Huntington Planning Commission
Monday, January 5, 2026 – 5:30pm

Issue: A site plan review for a hotel development located at 550 Kinetic Drive that is approximately 2.03 acres. The parcel is zoned C-2 Highway Commercial.

Location: 550 Kinetic Dr., Huntington, WV 25701

Petitioner/Property Owner: Emerald Hospitality LLC, 489 Ironwood Gate Dr., Princeton, WV 24740

MECHANICAL
FIRST FLOOR PLAN

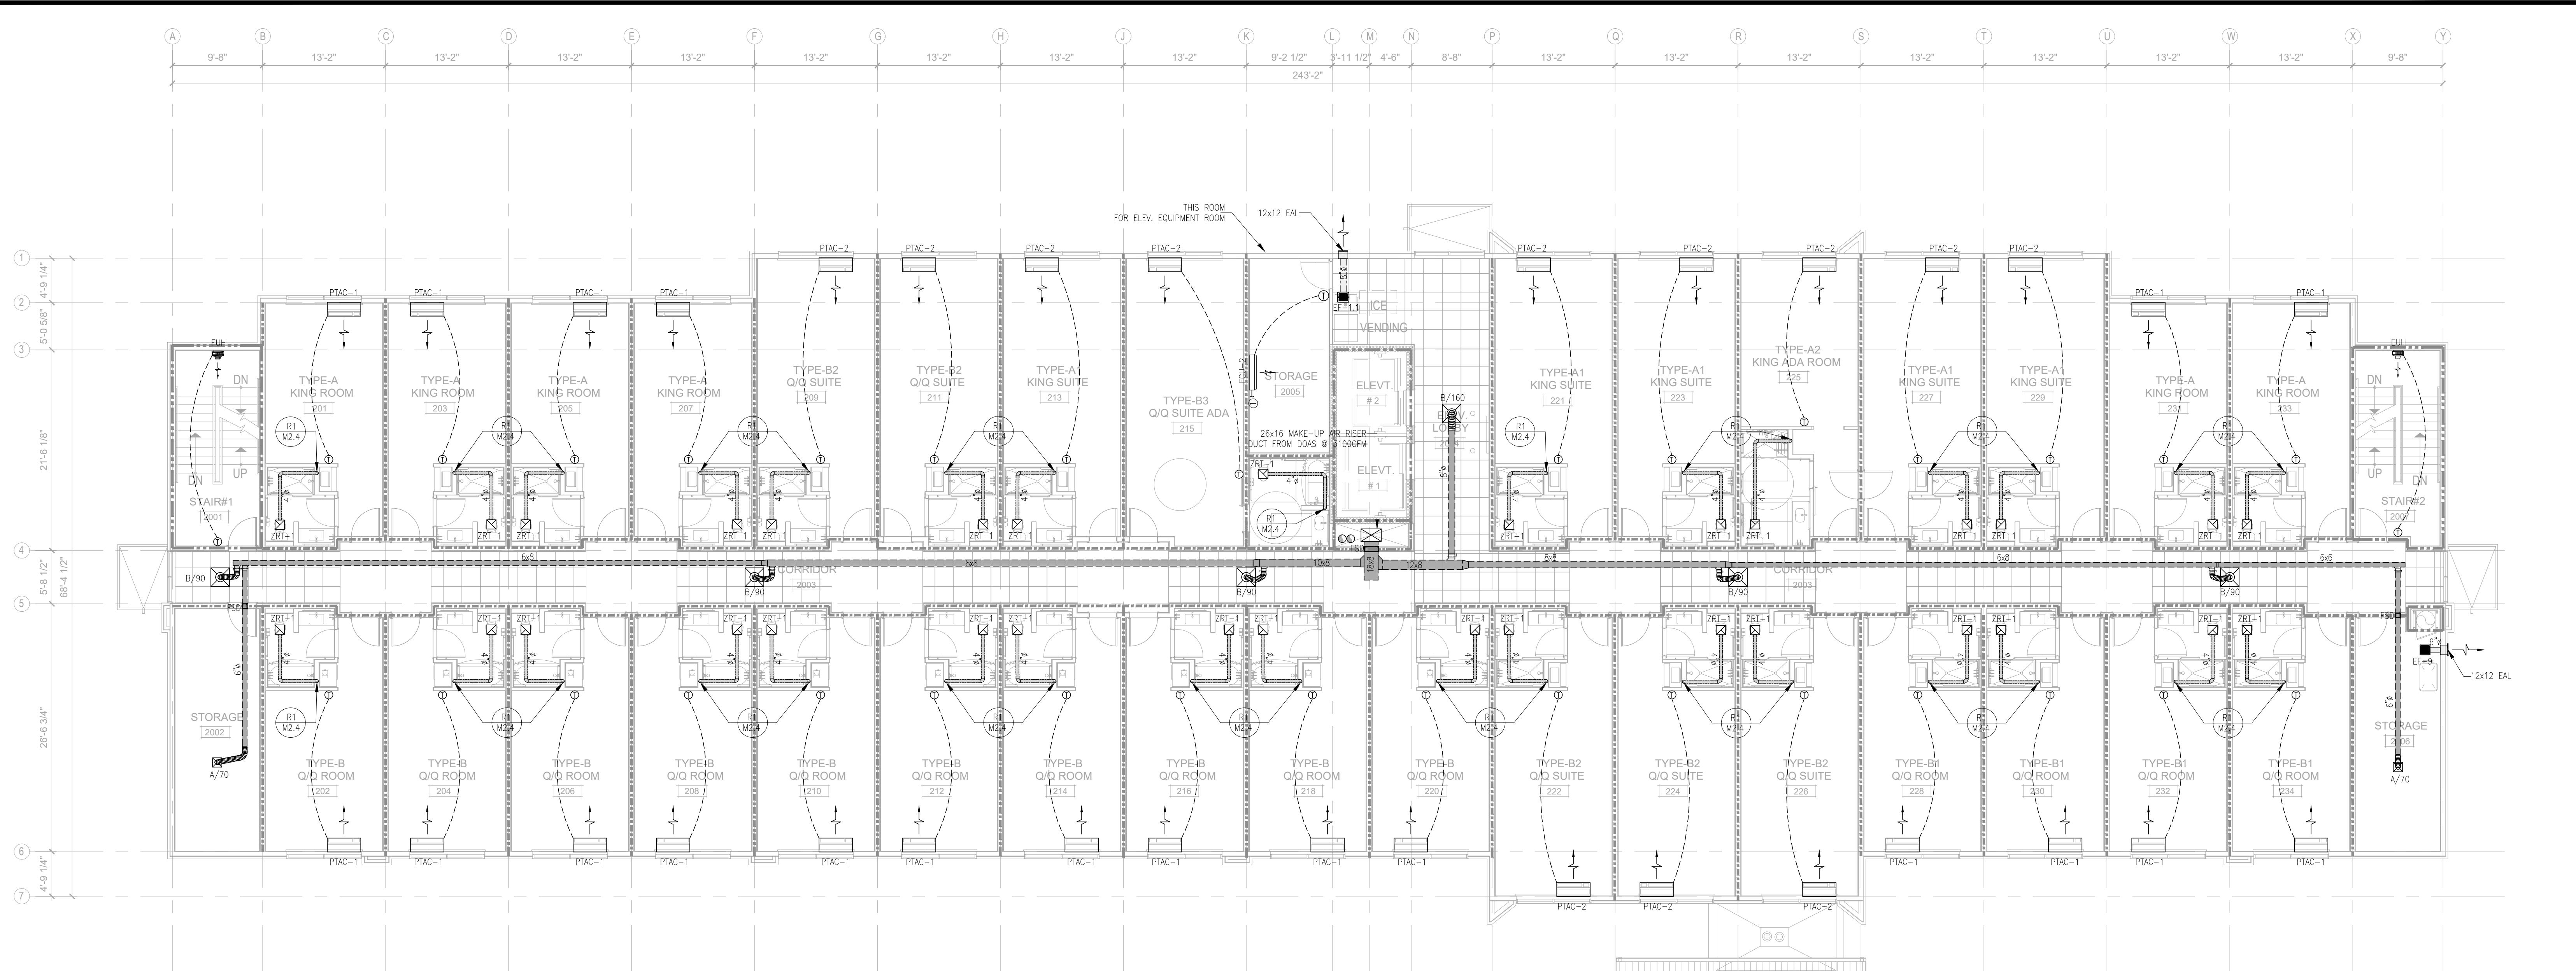
We have marked up your drawing for information purposes we have a 3" Plastic line laid in front of the property for other gas users in the area. We do not see a gas service line on these plans. With that said do they plan to use gas, if so we need to know the total load(preferably a list of items with gas and their load), and any irregular operating conditions.

Attached are the mechanical plans that include potential gas service.
